### Proposed Revisions to a Standard Plans Index

Index Number: 120-001

Index Title: Embankment Utilization

**Summary of the changes:**

INDEX	SHEET
120-001	1 of 3

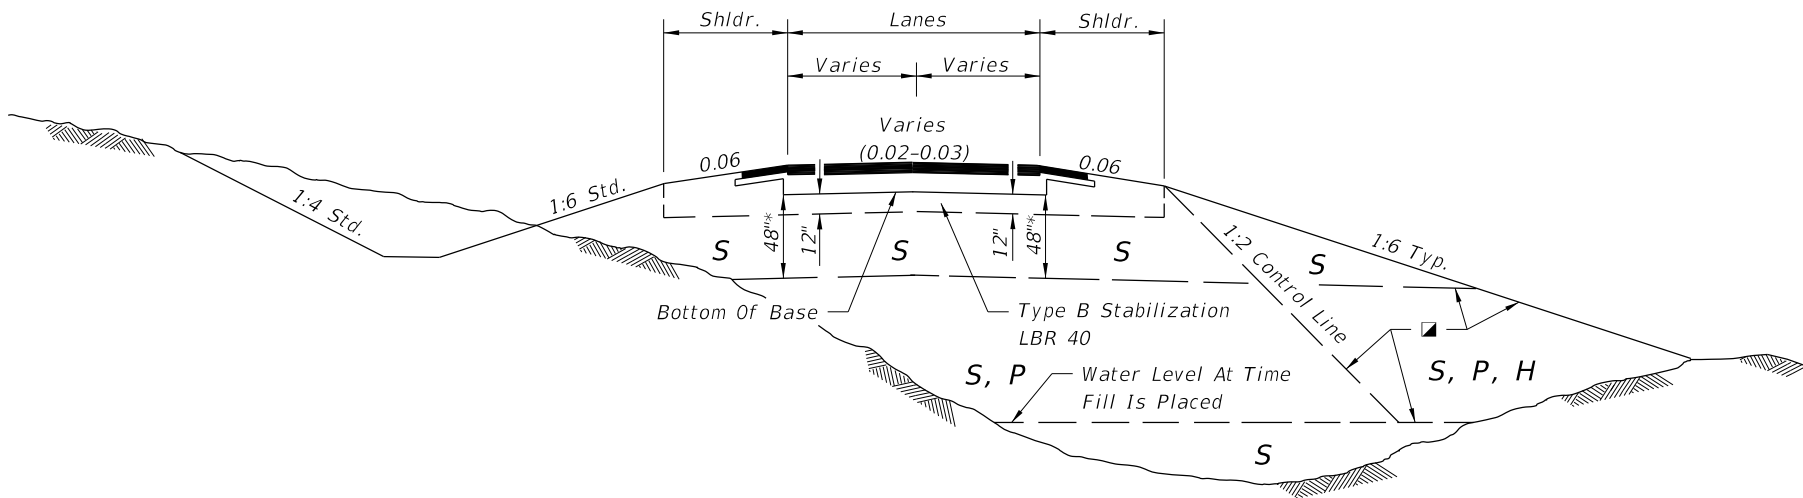
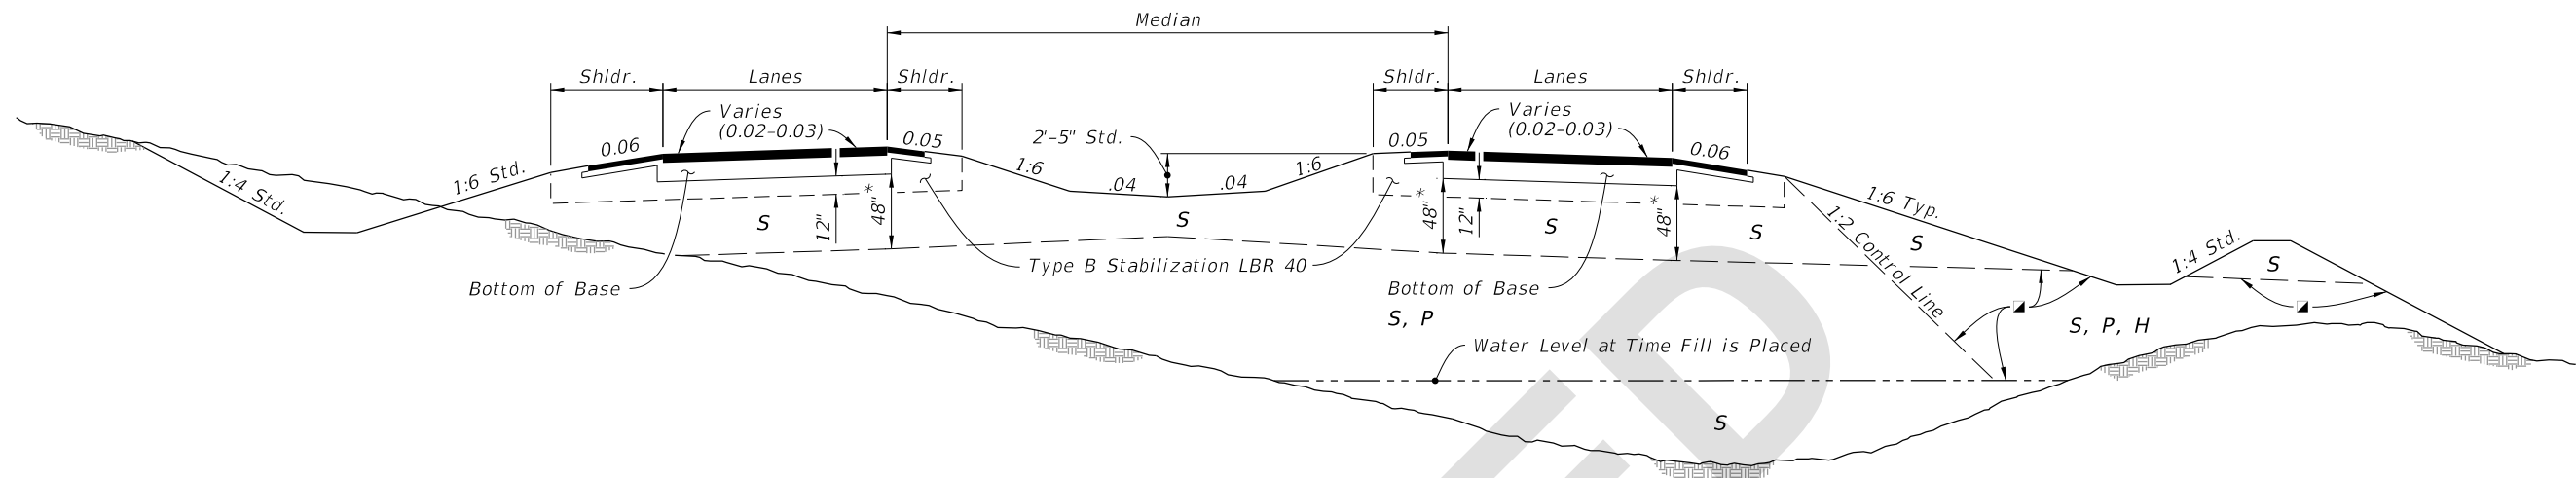
Update Note 4 to reference proper testing

Specification 120 and Index 120-001 have contradicting testing information. Change Index to "Perform tests in accordance with FM 1-T 267."

**FM 1-T 267**

- Select (S) soils having an average organic content of more than two and one-half (2.5) percent, or having an individual test value which exceeds four (4) percent, are not permitted in the subgrade portion of the roadbed. Select (S), Plastic (P), or High Plastic (H) soils having an average organic content of more than five (5) percent, or an organic content individual test result which exceeds seven (7) percent, are not permitted in the portion of embankment inside the control line, unless written authorization is provided by the District Geotechnical Engineer; these soils may be used for embankment construction outside the control line, unless restricted by the Plans or otherwise specified in the Plans, provided they can be compacted sufficiently to sustain a drivable surface for operational vehicles as approved by the Engineer. Determine average organic content from the test results from a minimum of three randomly selected samples from each stratum or stockpile of a particular material. Perform tests in accordance with FM 1-T 267.
